Access Compliance Report Public Rights-of-Way (Curb Ramps)

Main Street: TUCKER_LN Cross Street: FOSTER_RD Location: NW

ADA ID: RPRK211209123441 Ramp Type: Type 1 - Perpendicular Diagonal Initial Pass/Fail: Pass Overall Compliance: No Severity Score: 10

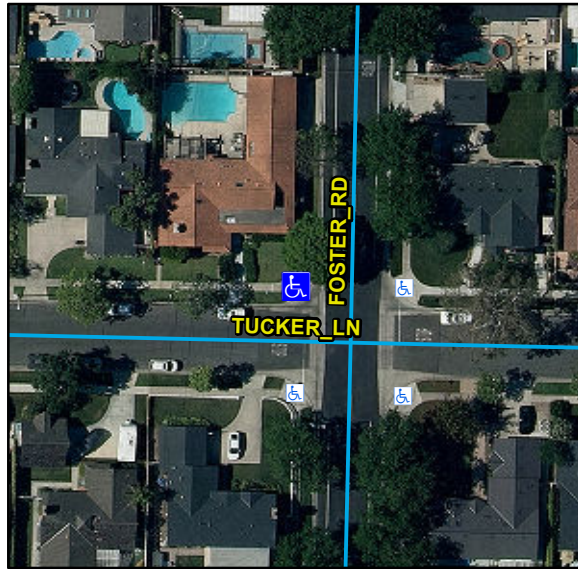
Surveyor Notes:

N/A

Remove & Replace Curb Ramp With Two New Directional Ramps or Equivalent. Remove & Replace Gutter.

R204.3, R305, R304.5.3, STD 1115
